**CITY OF LEWISTON**  
**PLANNING BOARD MEETING**  
Monday, June 25, 2018 – 5:30 P.M.  
City Council Chambers – First Floor  
Lewiston City Building  
27 Pine Street, Lewiston, ME

**RE: June 25, 2018 Agenda Item IV a**

**Walsh Engineering Associates, Inc., on behalf of Dirigo Federal Credit Union is seeking to replace the existing building with a new building (3,922 sf. footprint and 9,635 total sf.) and 34 space parking lot at 381 Main Street.**

**RE: Dirigo Federal Credit Union, 381 Main Street**

**EXTERIOR ELEVATIONS**

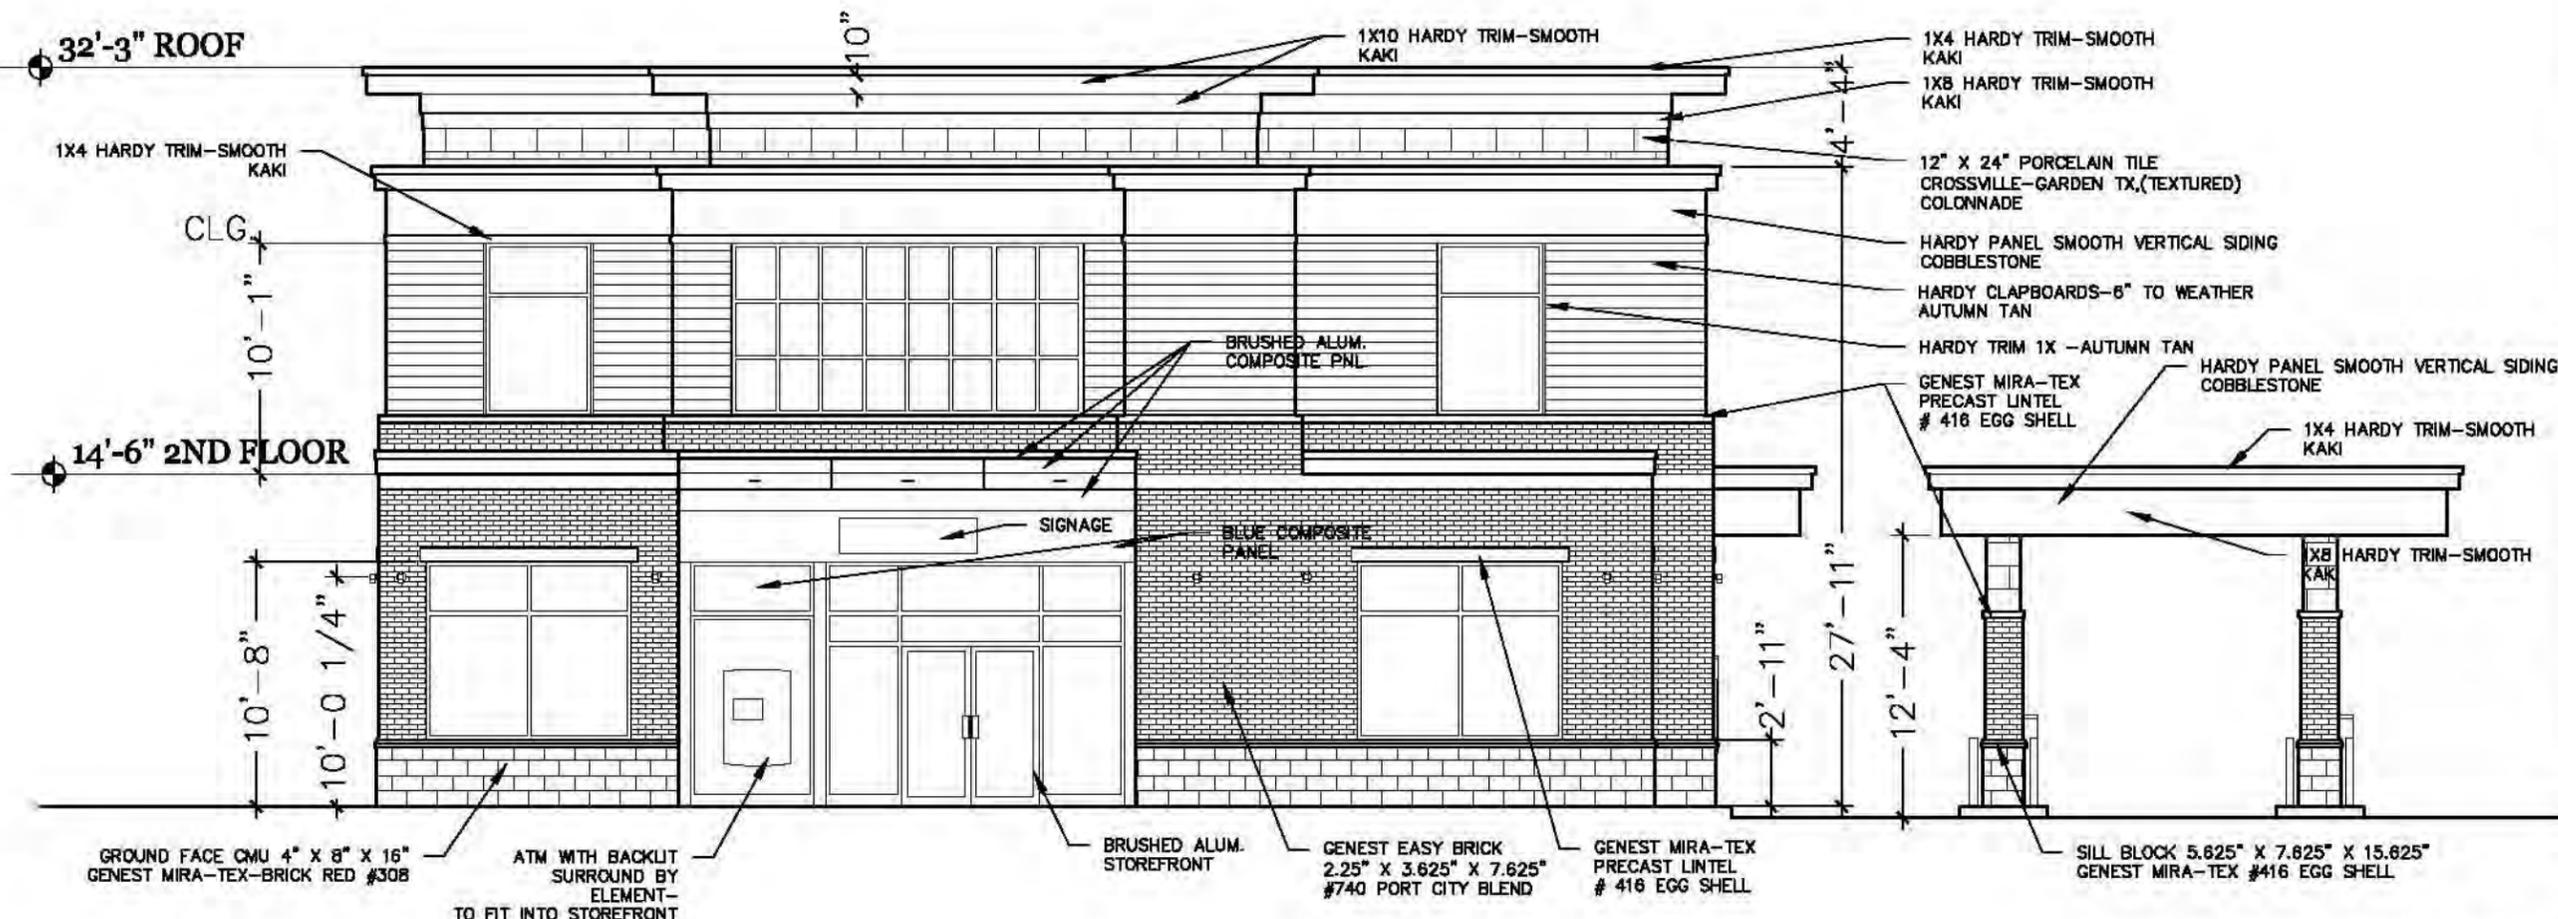
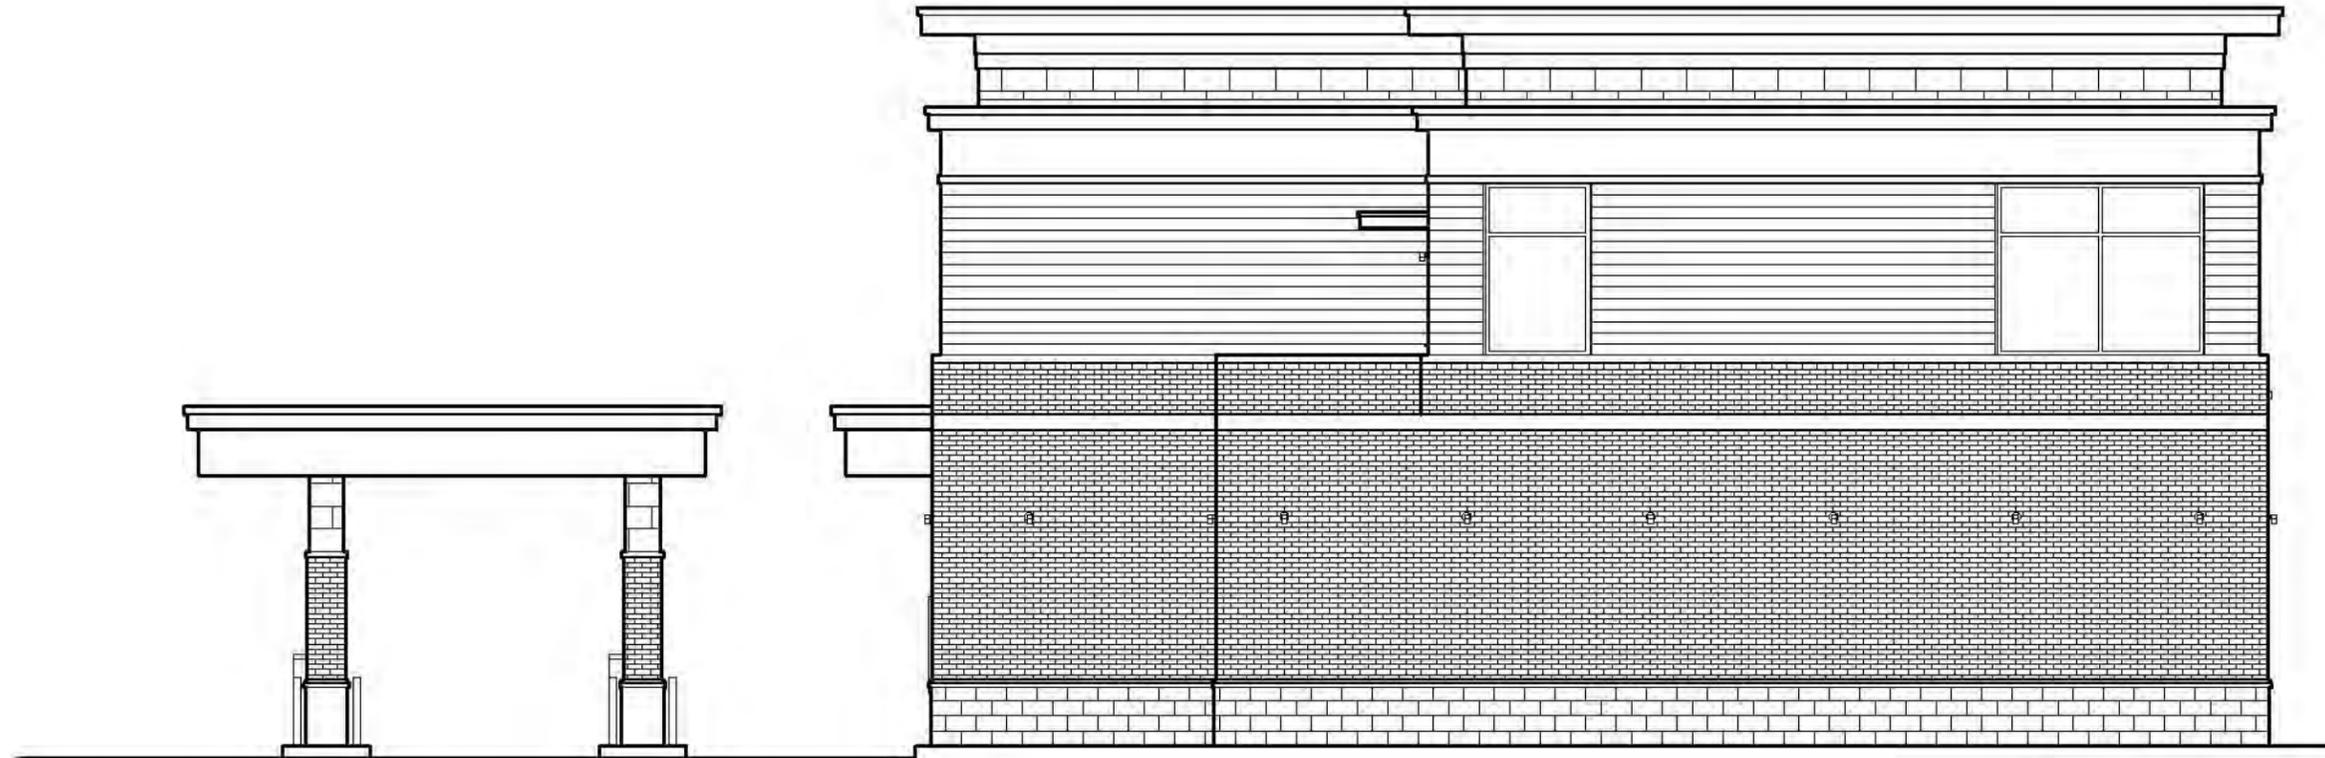
- Building elevations are provided with the height of the canopy noted.
- We are providing additional landscaping along the Oak Street side.
- The light poles have been revised to 20 feet.

**7 CURB RAMP DETAIL**  
C3.2 NOT TO SCALE

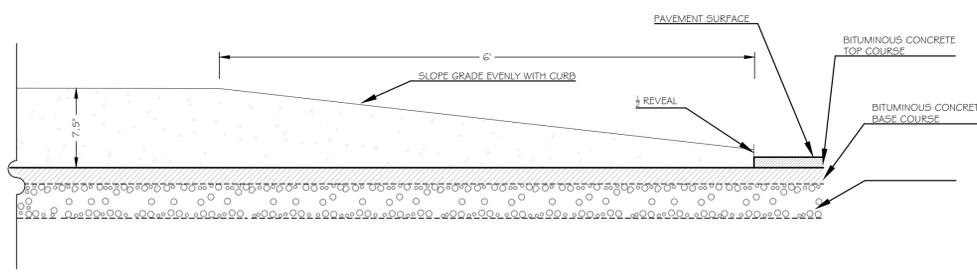
- New ADA curb ramps, with warning plates, will be installed at the two new Main Street driveways.

- We have added ADA ramps on the two driveways at Main Street.
- We have included a striping plan for the full length of the block, Elm Street to Holland.

**4 UNDERGROUND UTILITY TRENCH (MULTIPLE PIPE)**  
C3.3 NOT TO SCALE

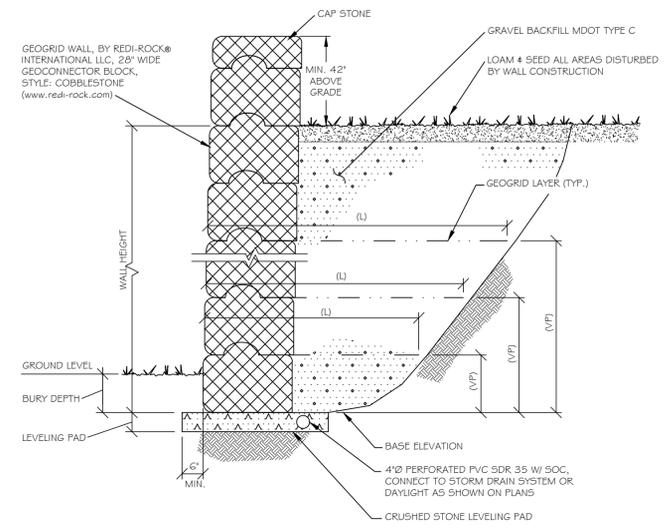
- Conduit below the roadway will be schedule 80.
- Attached is a Summary of Design Development Standards.
- We have added a signature block for the approval.
